GS# 104-215 Jones Hall Interior Renovations (RE-BID)
Mississippi University for Women

Addendum No. 2

SHEET MD101R1

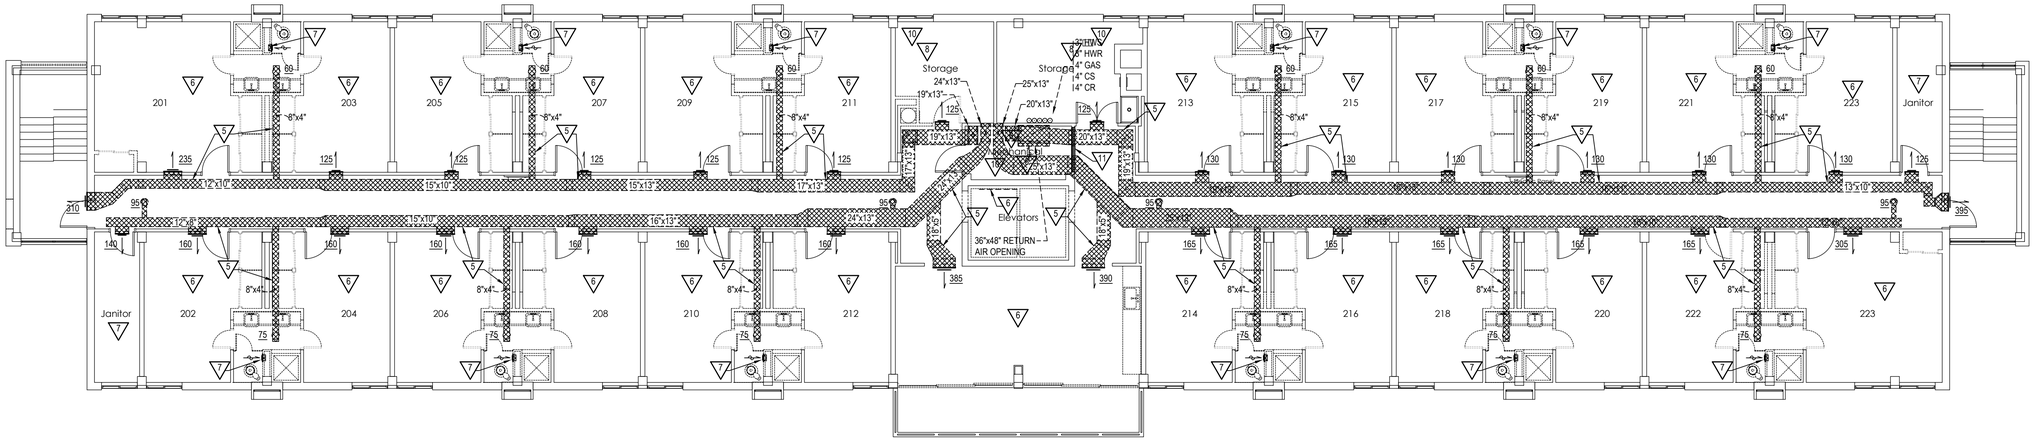
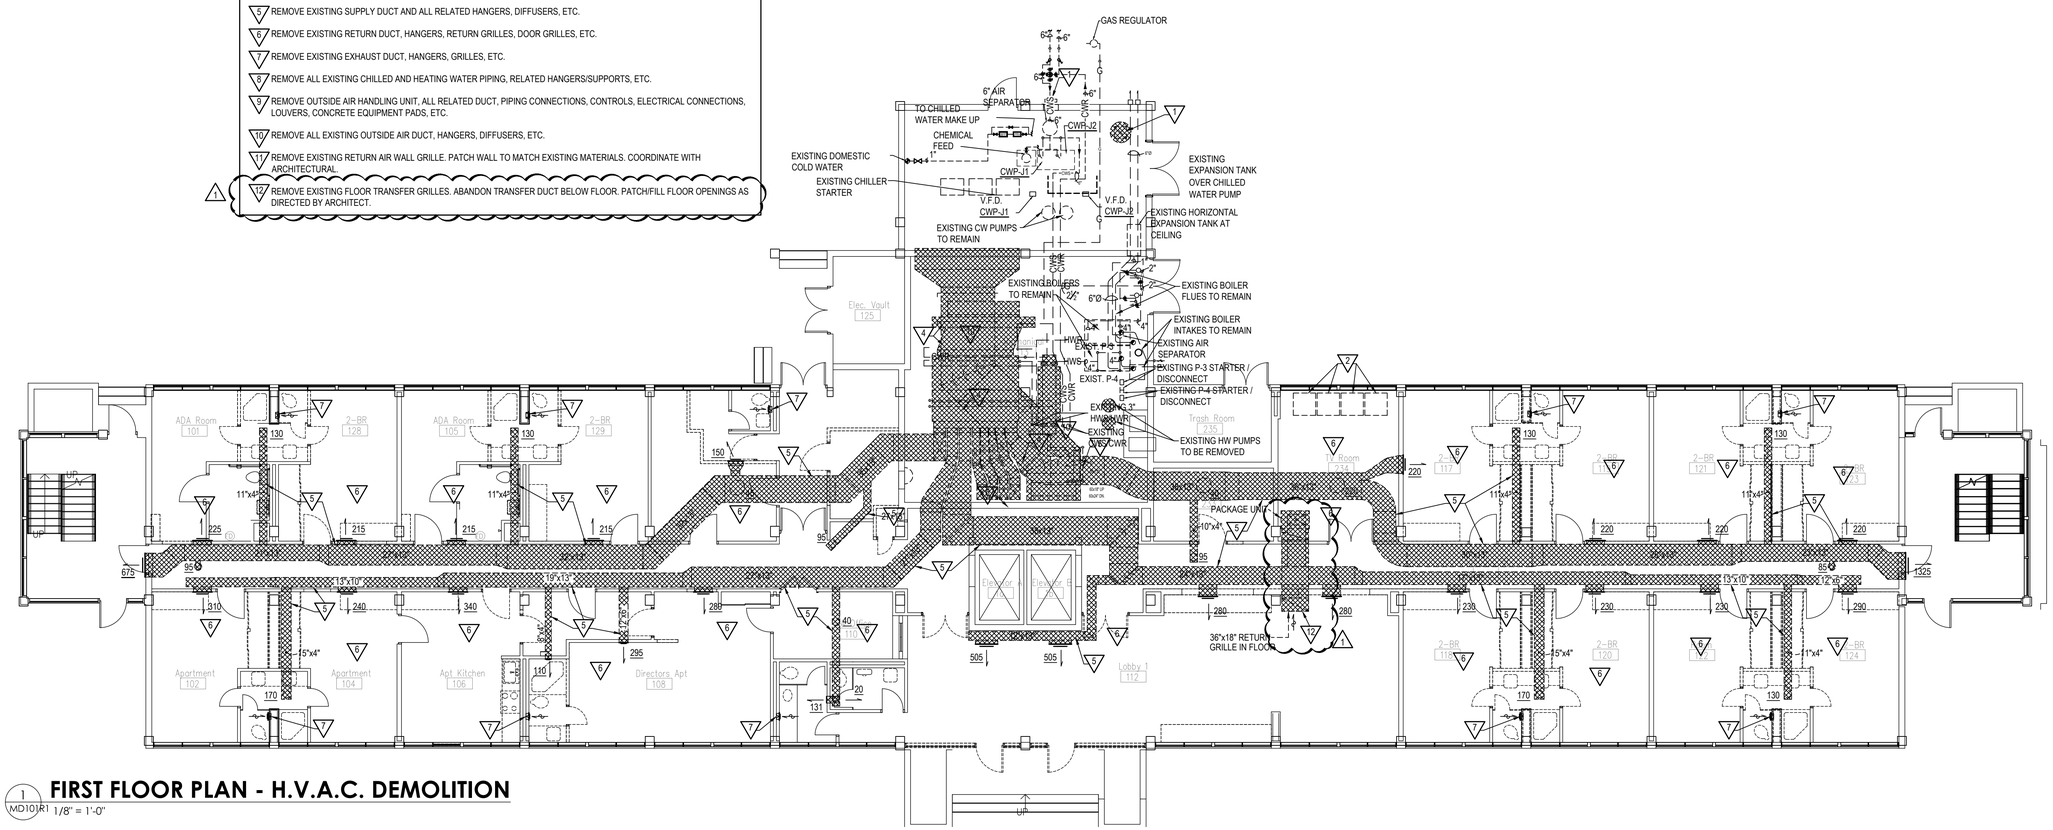
Item No. 2: Drawing, Sheet MD101: Revised note for under floor transfer duct as shown on attached Drawing MD101R1

12. REMOVE EXISTING FLOOR TRANSFER GRILLES. ABANDON TRANSFER DUCT BELOW FLOOR. PATCH/FILL FLOOR OPENINGS AS DIRECTED BY ARCHITECT.

SHEET E005

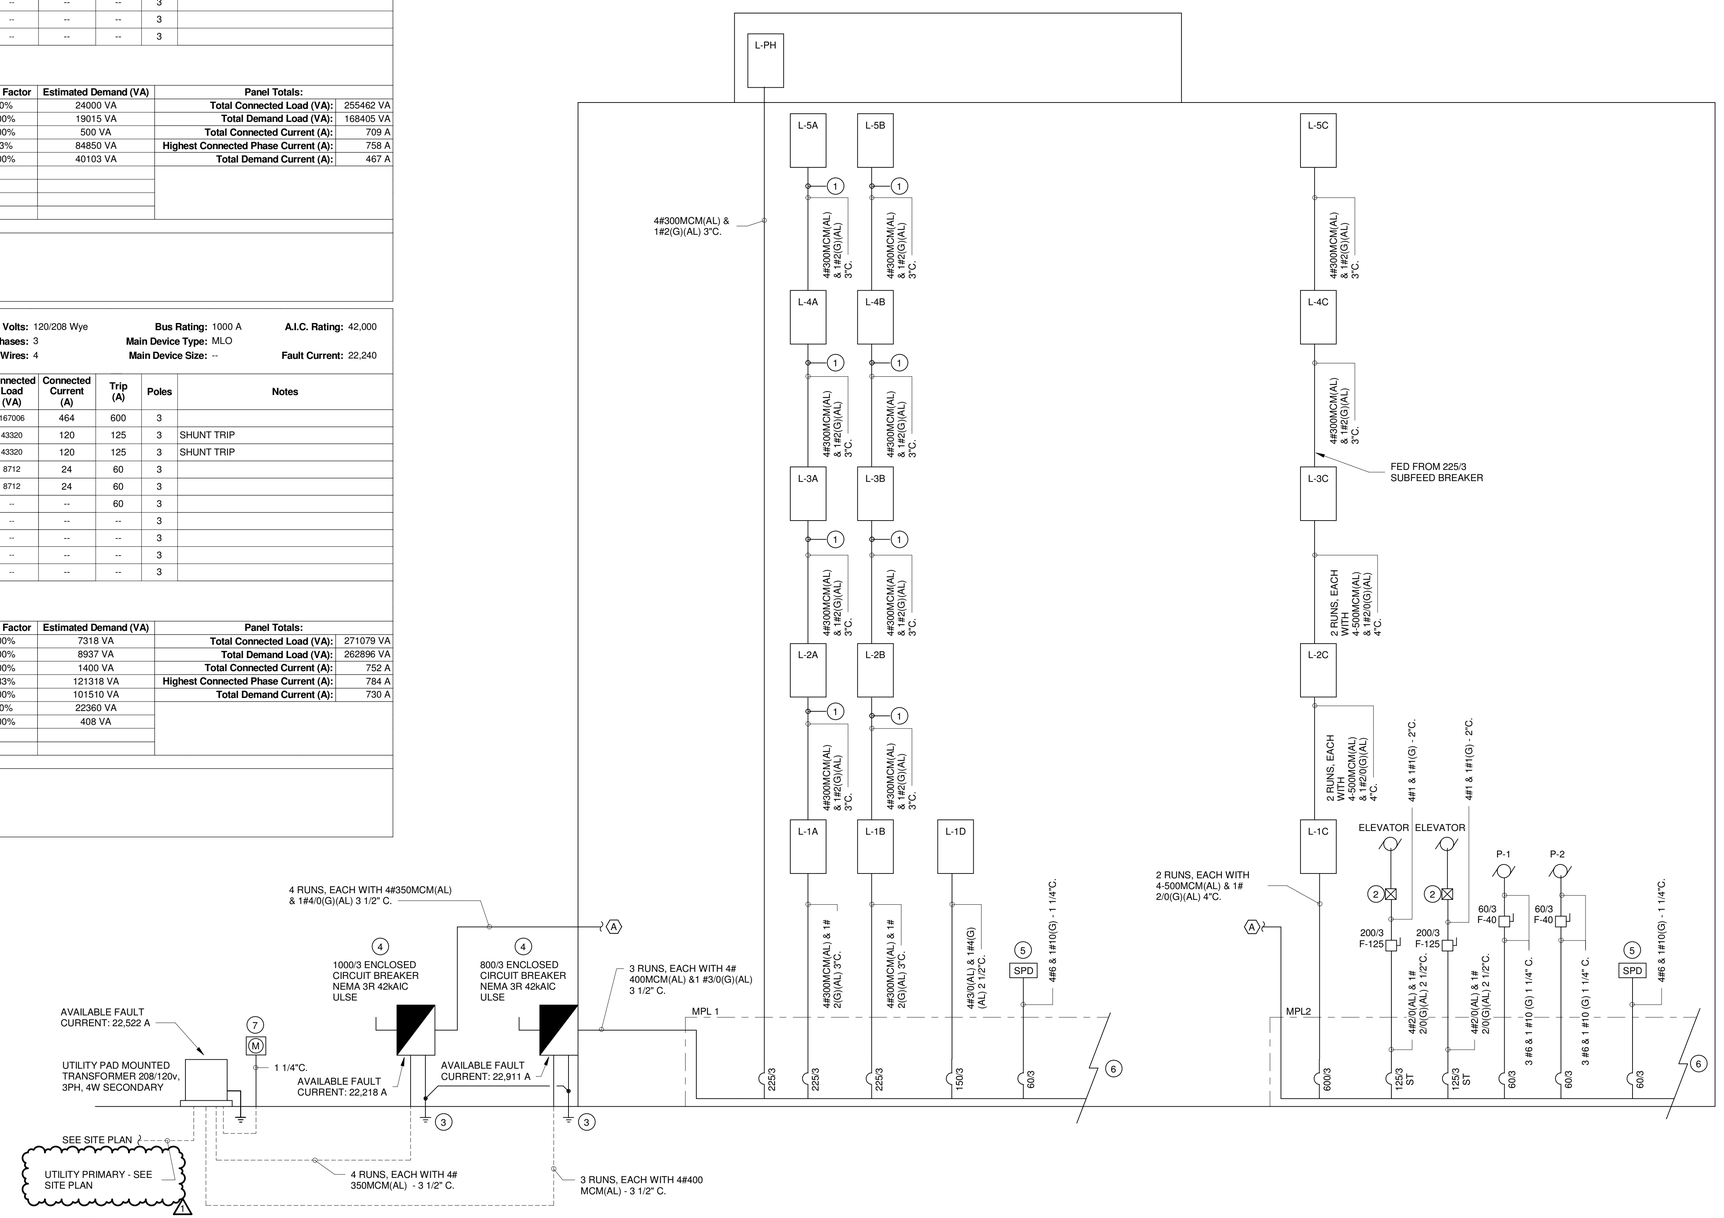
Item No. 3: Drawings: Revise Sheet E005 and replace with attached Sheet E005. Revisions included updating Utility primary feeder note.

SHEET E009

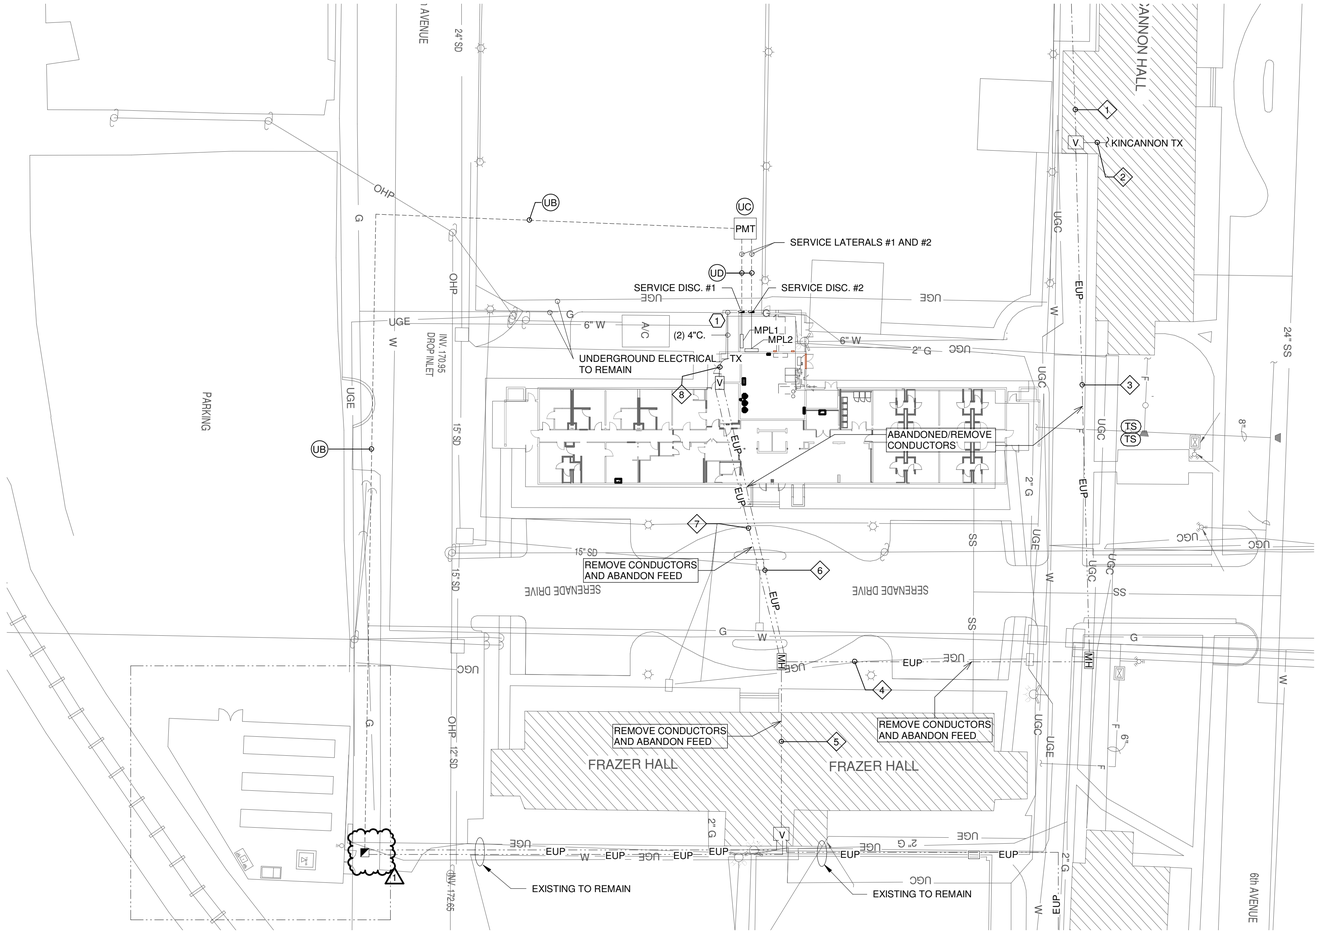
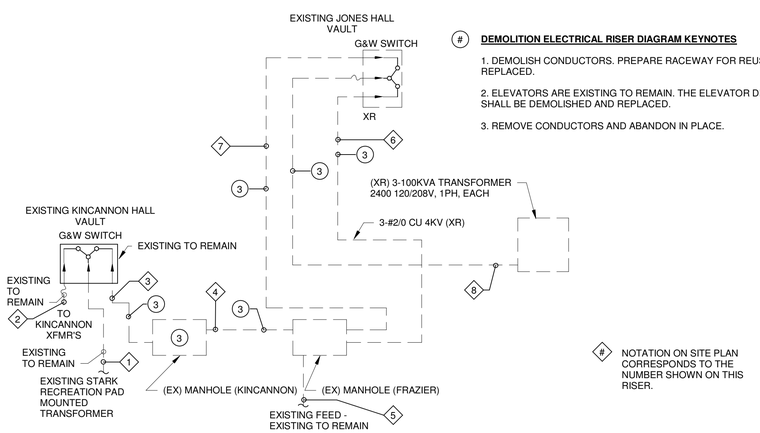
Item No. 4: Drawings: Revise Sheet E009 and replace with attached Sheet E009: Revisions included updating site plan power and feeder notes.
